EPA Superfund Record of Decision:

**Tyler Refrigeration Pit,
Smyrna, DE
5/10/1996**

RECORD OF DECISION

Responsiveness Summary

Figure 7
LOCATION OF SOURCE AREAS
DNREC REMEDIAL INVESTIGATION

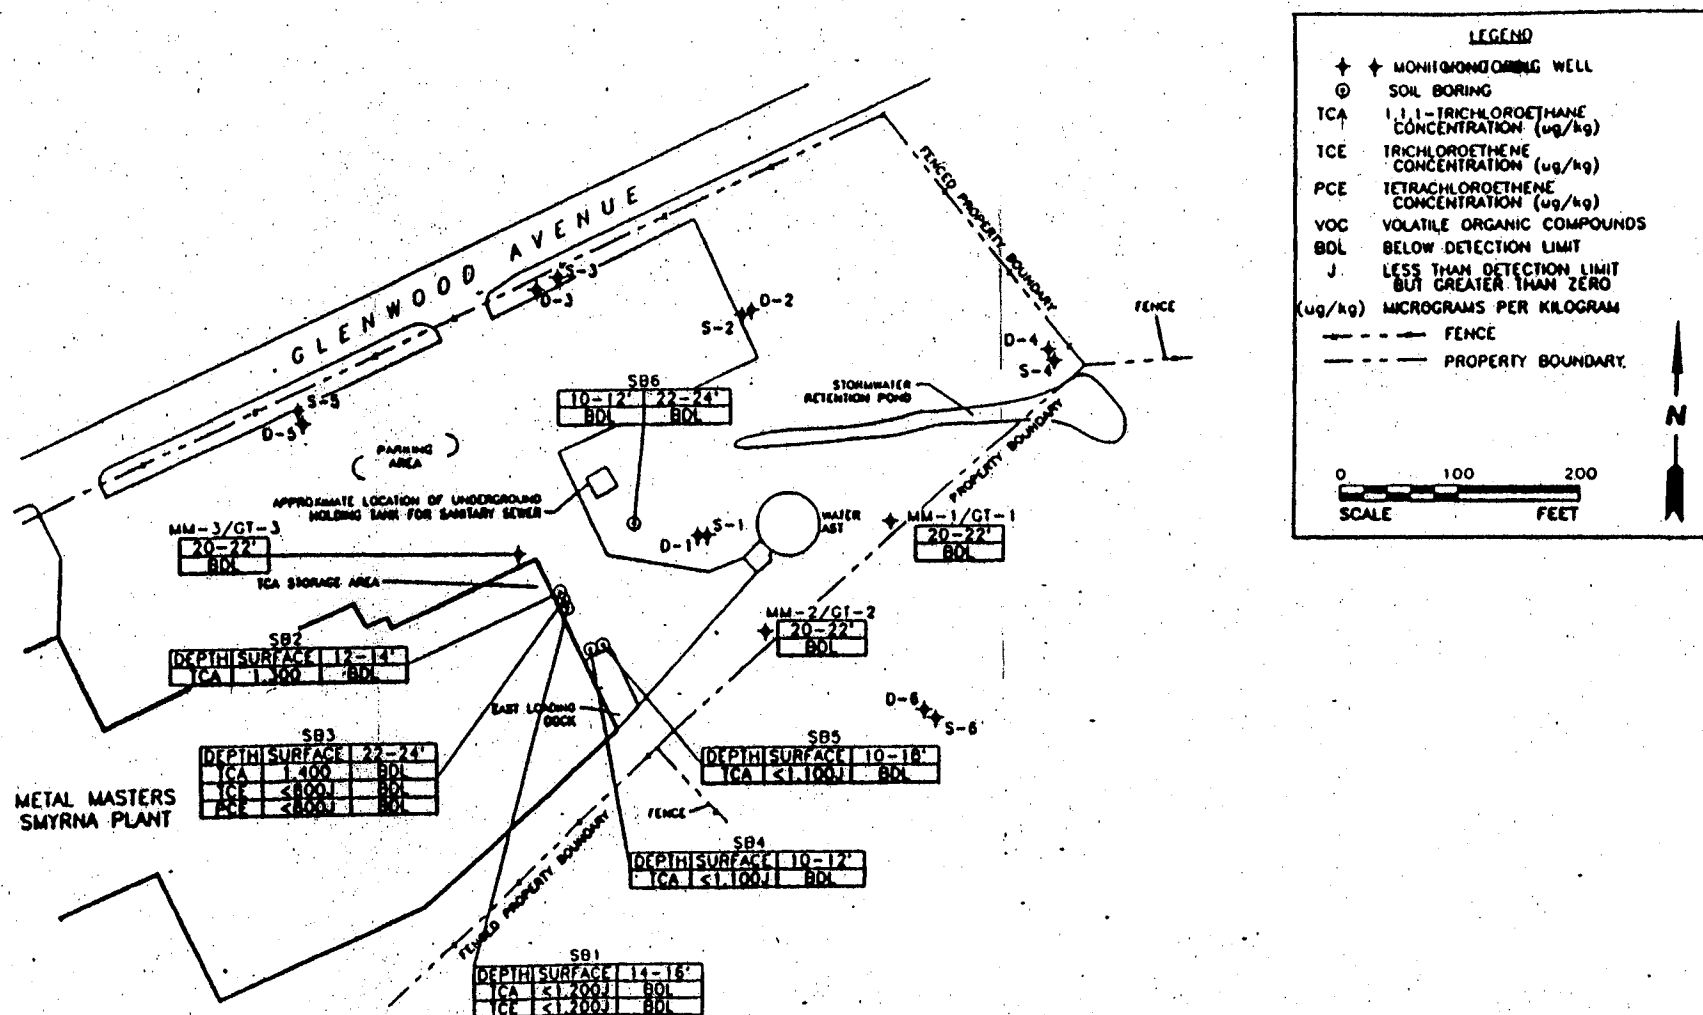
2. Volatile organic compound concentrations in all three sampling events are extremely low and there is no active source area where groundwater quality is in question.

the last two rounds of sampling. Regarding the issue of an active source area, the suspected source based on the DNREC Proposed Plan of Remedial Action was the TCA Storage Area (refer to Figure 7). DNREC concluded that the TCA Storage Area does not likely represent a continuing source because Metal Masters is no longer operating its plant at this location and little contamination remains in the soil. However, existing contamination in the ground water can still migrate whether or not an active source area exists.
